**DELRAY
BEACH CLUB
RAISED TENNIS
& COVERED
PARKING**

**2001 S. OCEAN BLVD.
DELRAY BEACH, FL.**

THIS DRAWING IS NOT FOR CONSTRUCTION,
IT HAS BEEN ISSUED FOR GOVERNMENTAL
REVIEW AND/OR PRELIMINARY PRICING
ONLY

A1.01C

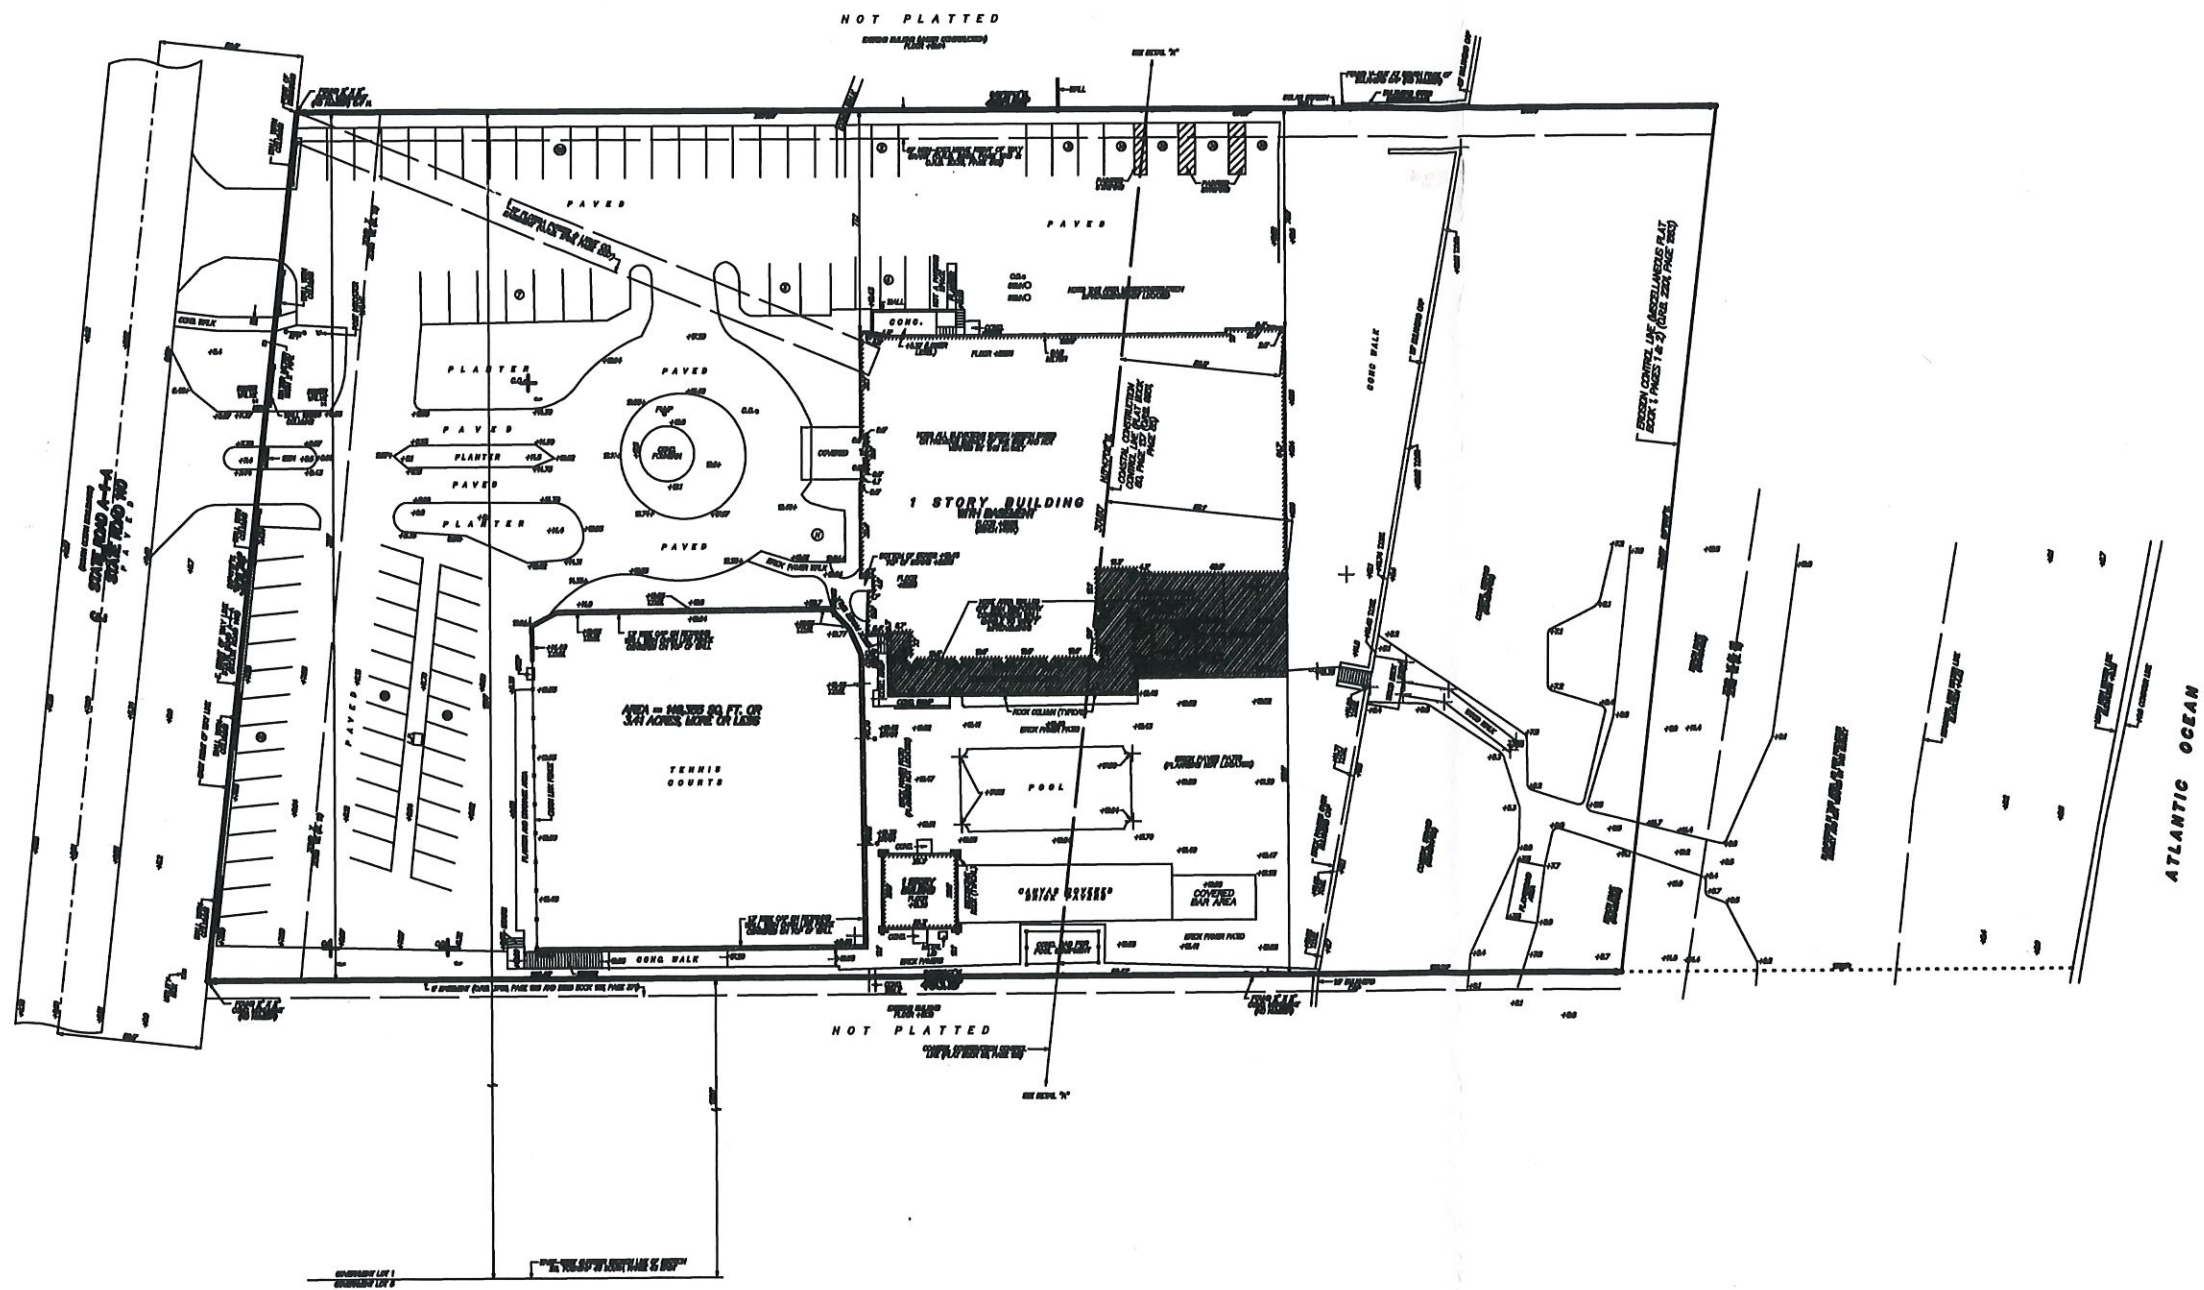
1 REVISED 9.3.2 AS PER PLANNING AND ZONING COMMENTS:
1. LANDSCAPE STRIP ON NORTH SIDE OF STRUCTURE HAS BEEN INCREASED TO A 5'-0" DEPTH.
2. BICYCLE PARKING SPACES HAVE BEEN ADDED.
3. A LIMITS OF CONSTRUCTION LINE HAS BEEN ADDED FOR CLARIFICATION.

2 REVISED 11.29.21 AS PER PLANNING AND ZONING COMMENTS:
1. ADDED (1) ADDITIONAL BICYCLE RAKE FOR A TOTAL OF (2).
3. ADDED THE 'AUTO-TURN' ANALYSIS.

REVISD 8/24/22 AS PER
PLANNING AND ZONING COMMENTS:
1. 5'-0" WD PERIMETER
LANDSCAPE STRIP HAS BEEN
PROVIDED BETWEEN PARKING
AREA AND RIGHT-OF-WAY.
2. ISLANDS ARE NOW 9'-0"
BETWEEN CURBING.
3. PARKING LAYOUT CHANGED.

1 GARAGE FLOOD ZONE PLAN
A1.03 SCALE : 1/8"=1'-0"

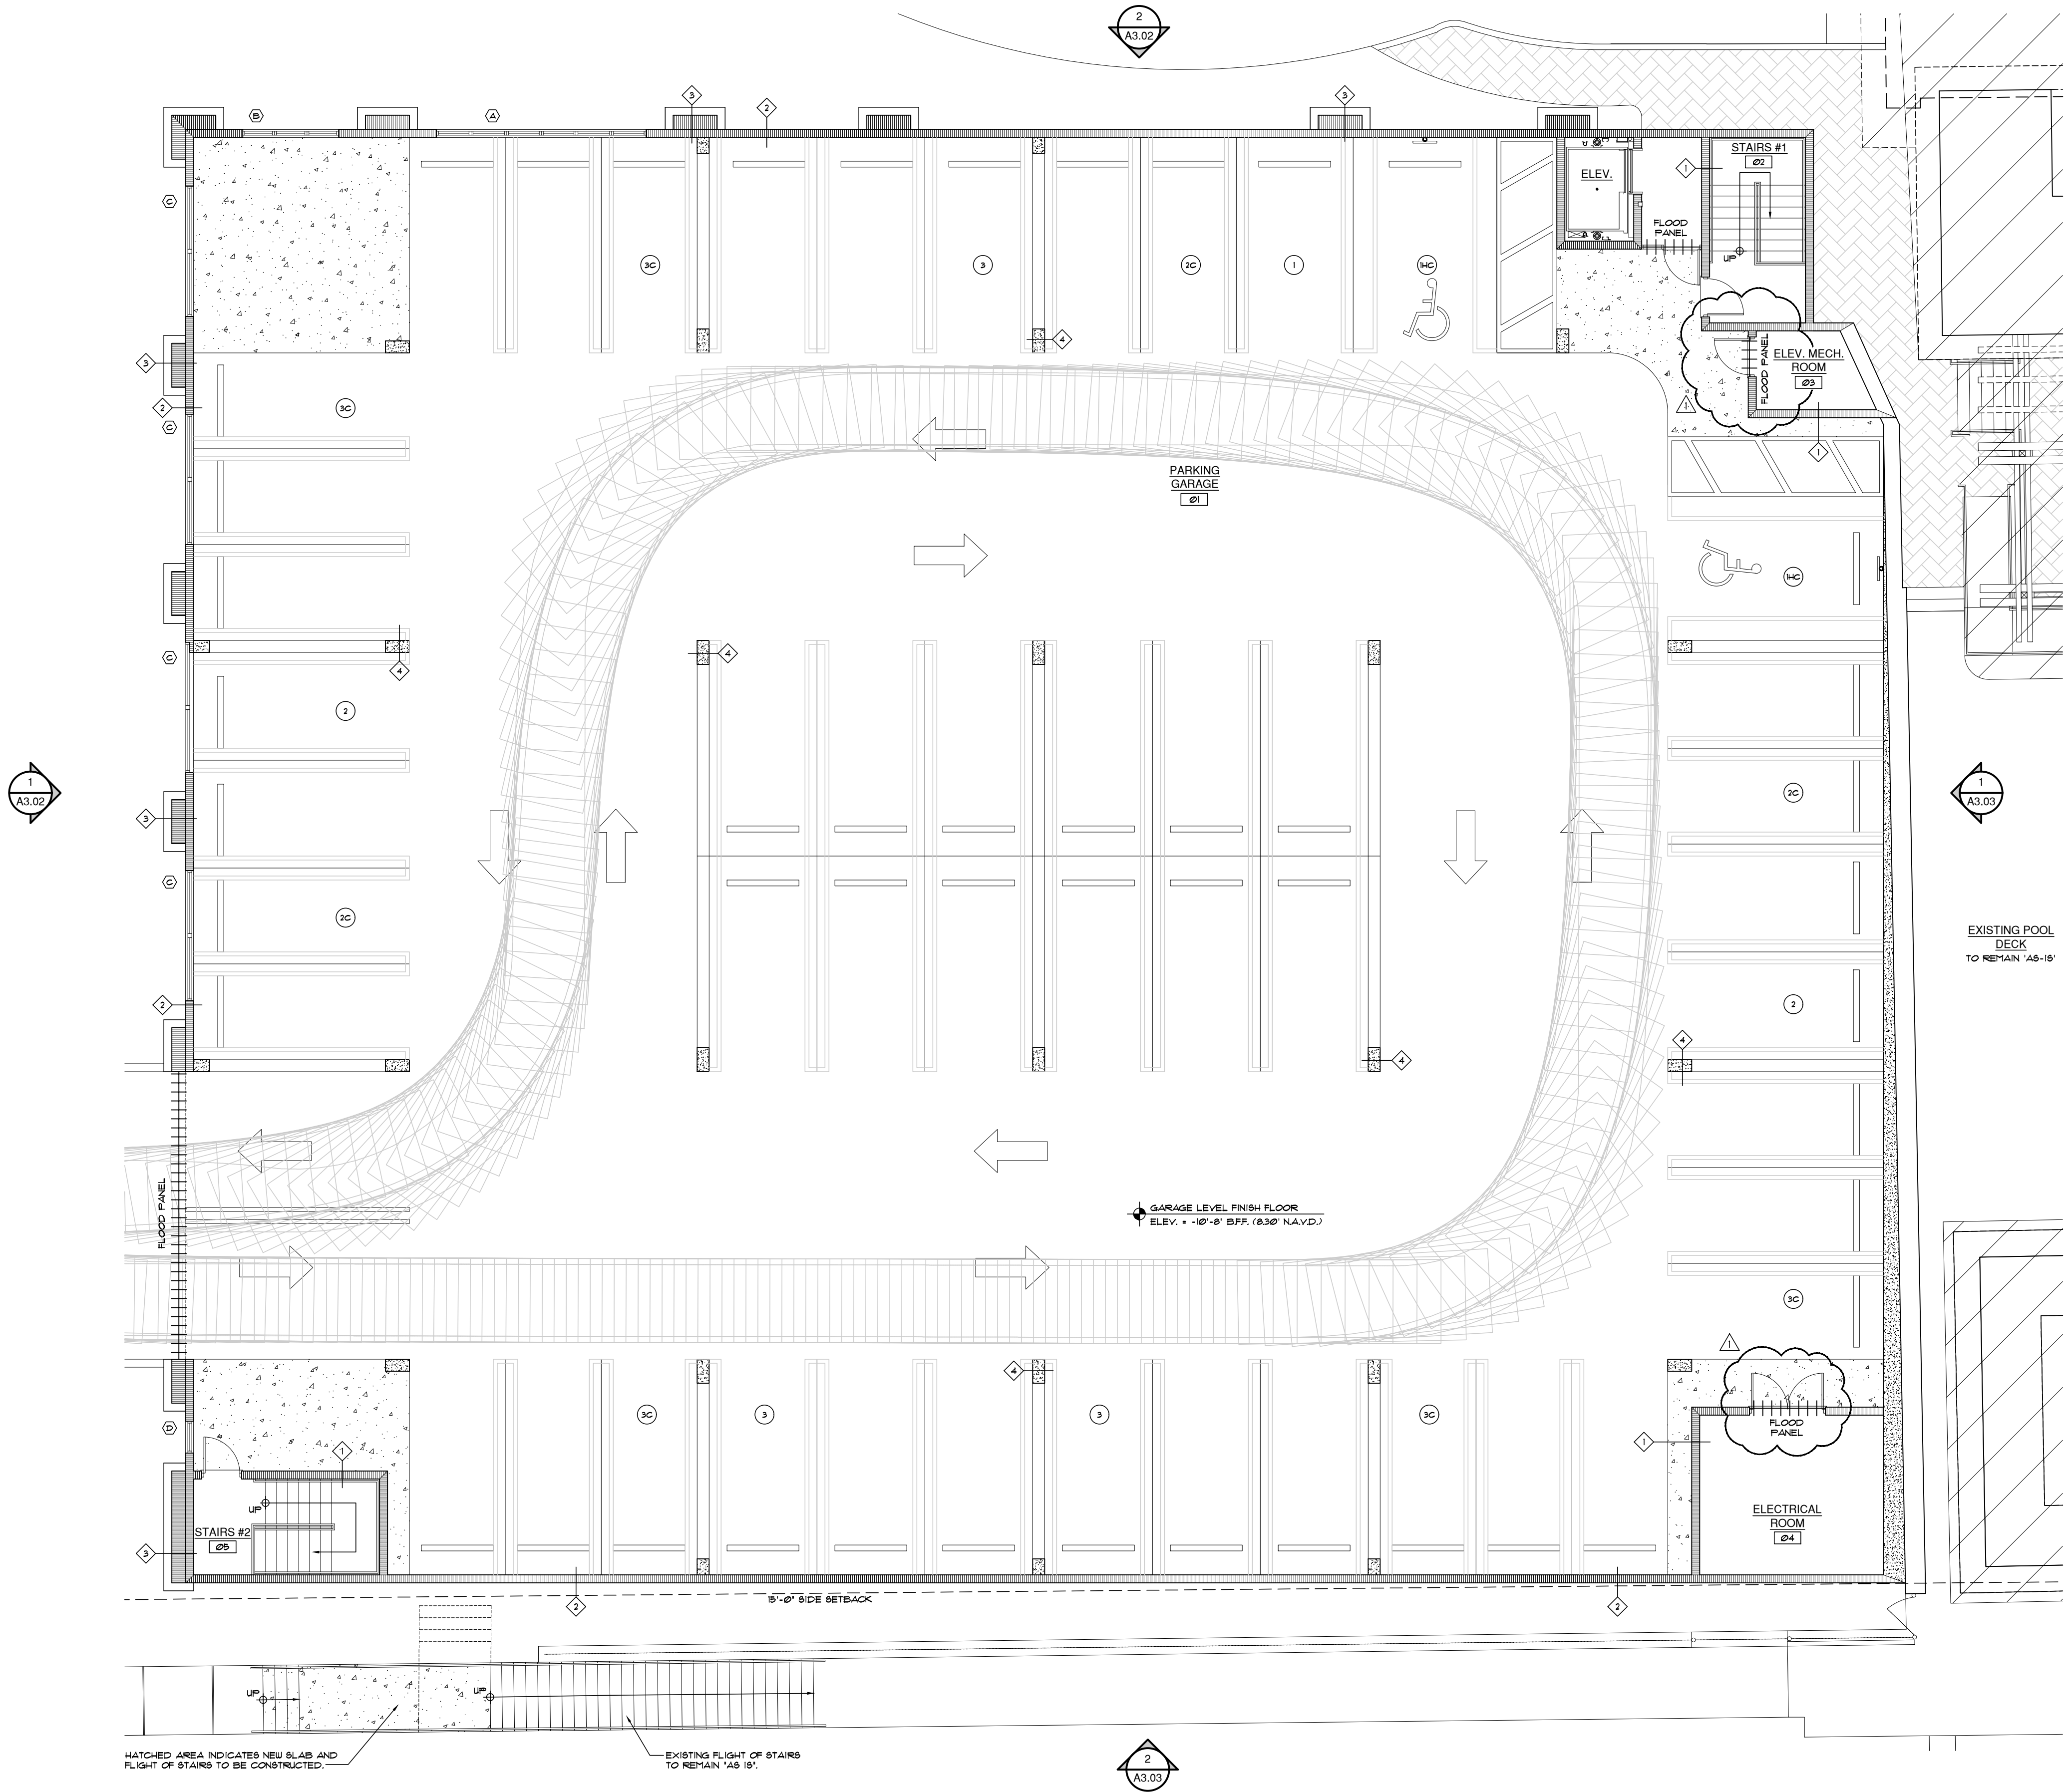
REVISIONS
REVISED 9.3.21 AS PER PLANNING AND ZONING COMMENTS. FLOOD PANELS HAVE BEEN PROVIDED IN BOTH THE ELEV. MECH ROOM AND ELECTRICAL ROOM.

**PROPOSED
GROUND FLR.
NOTED
PLAN**

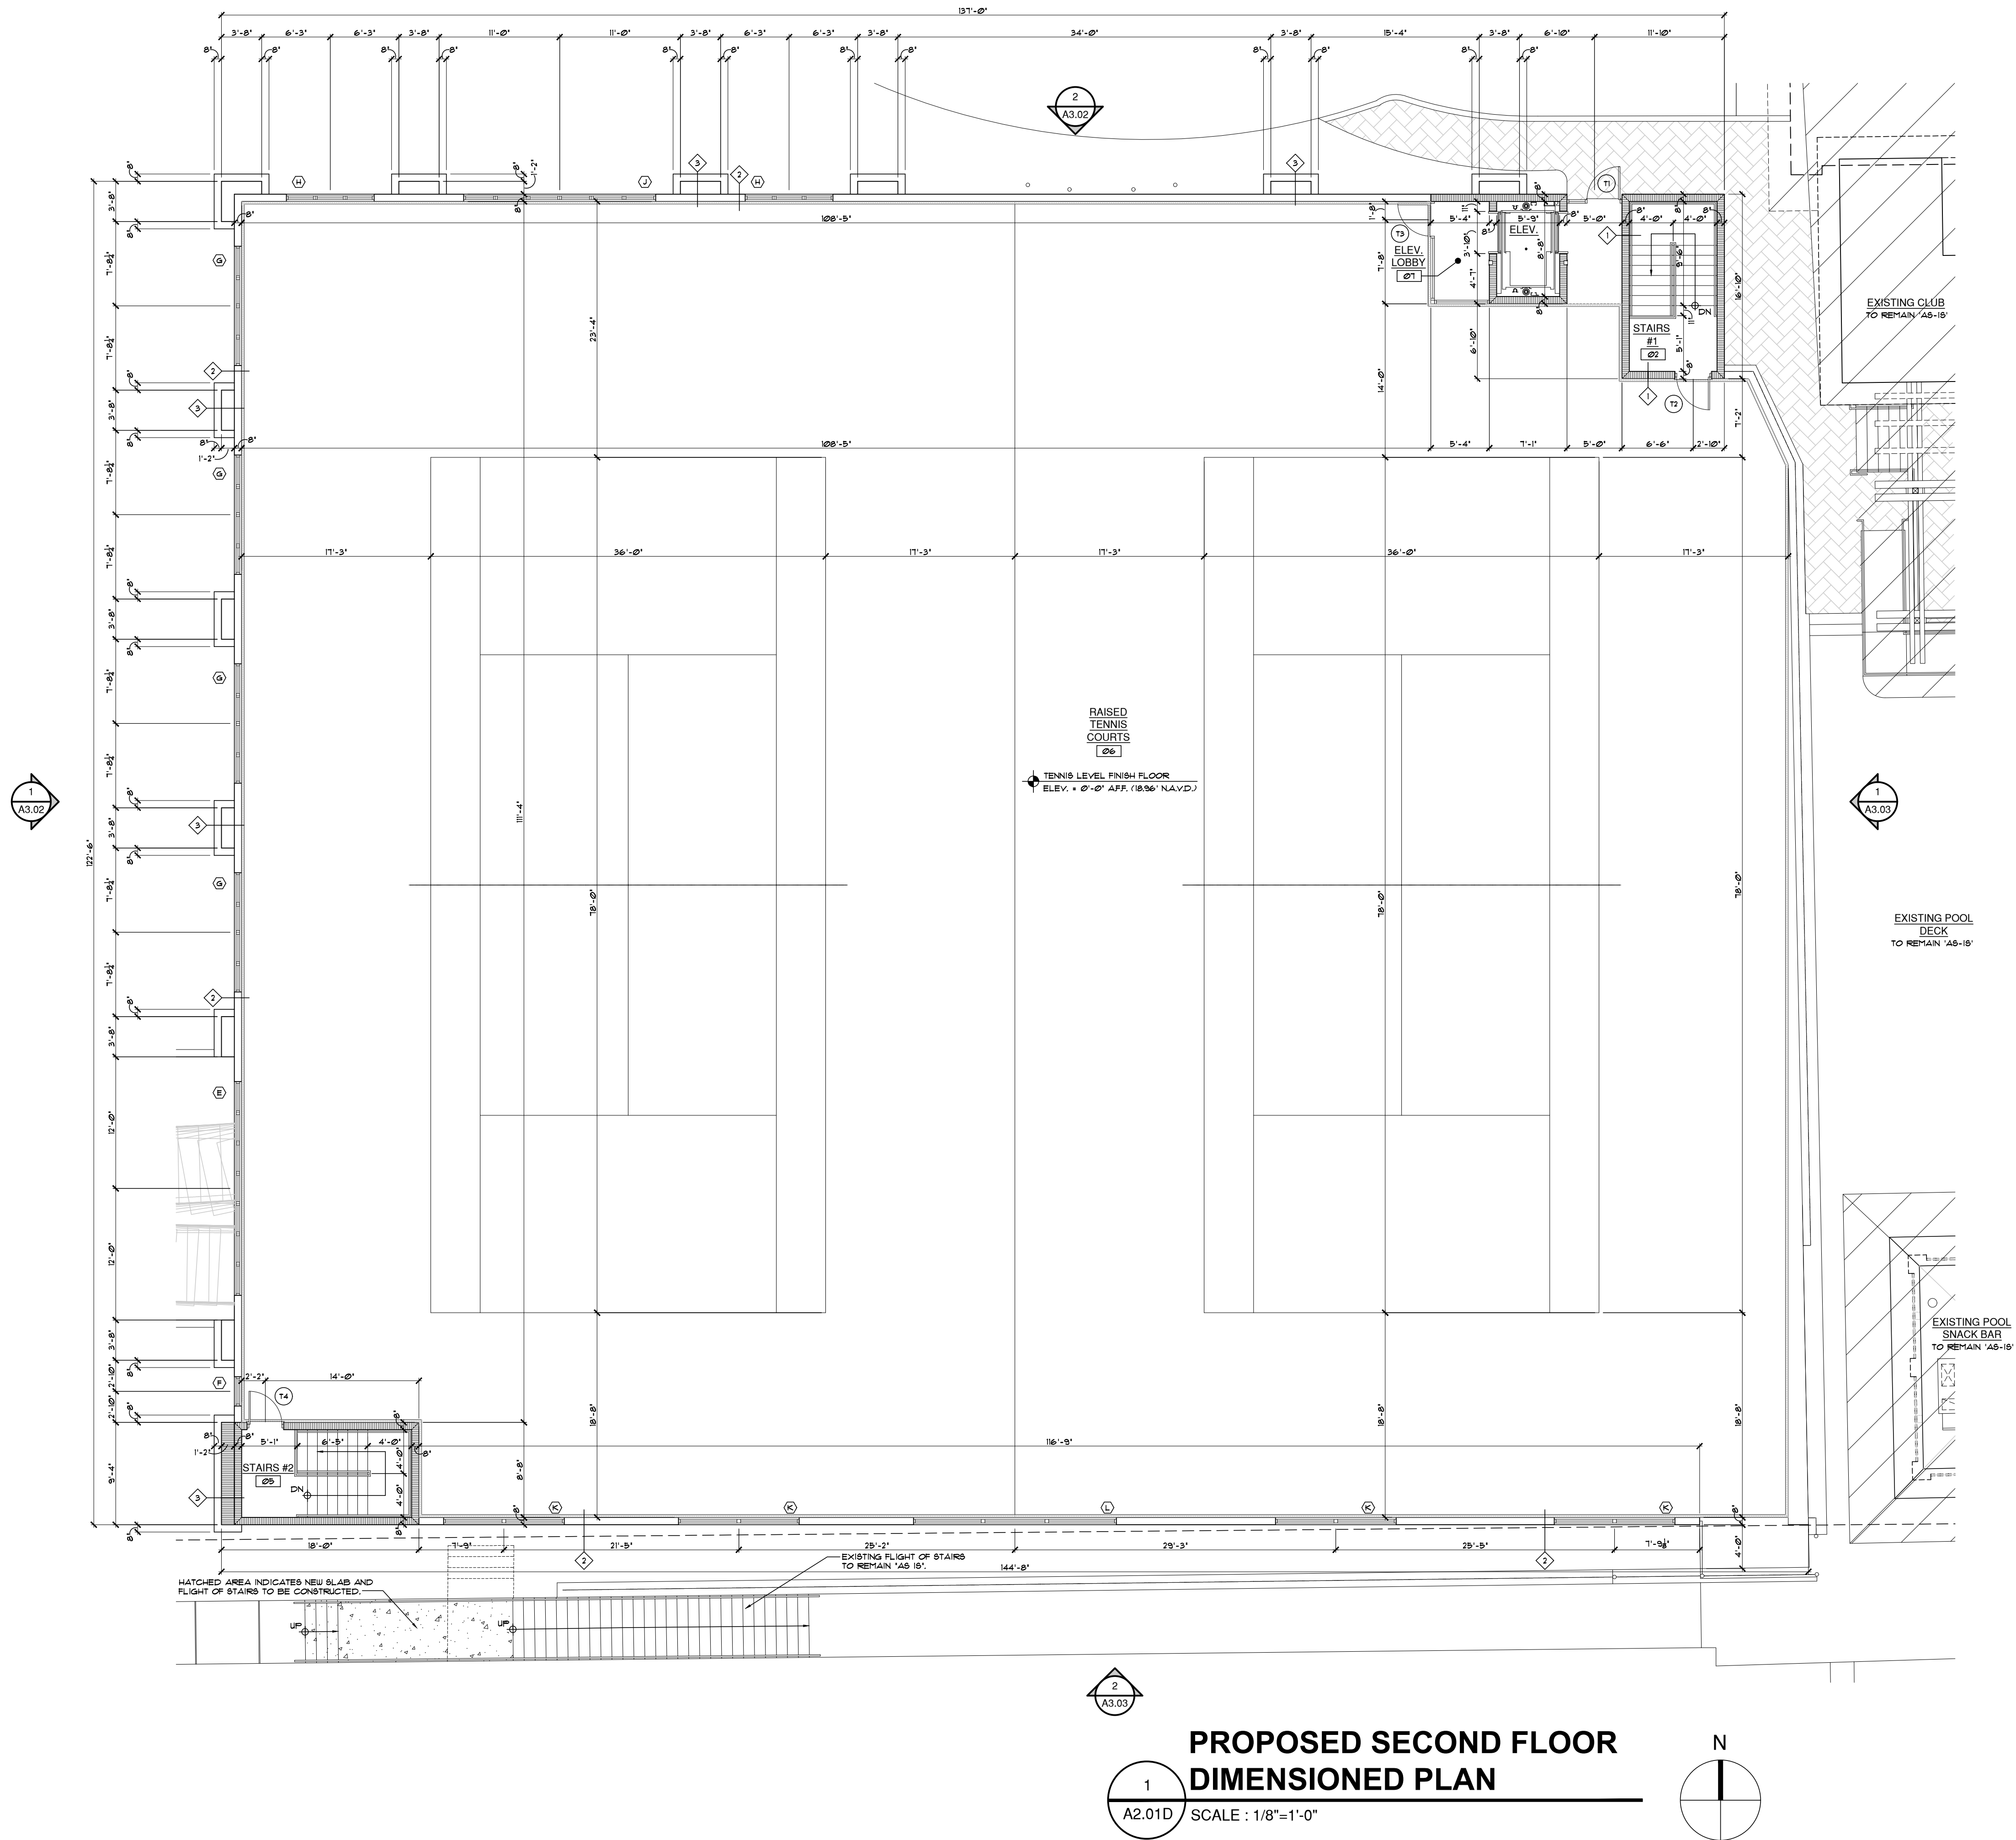
1. REVISED 11/12/21 AS PER PLAN REVIEW COMMENTS.
2. EXPLICIT LABELED COMPACT SPACE LOCATION.
3. SHOW "AUTO-TURN" WITHIN GARAGE.
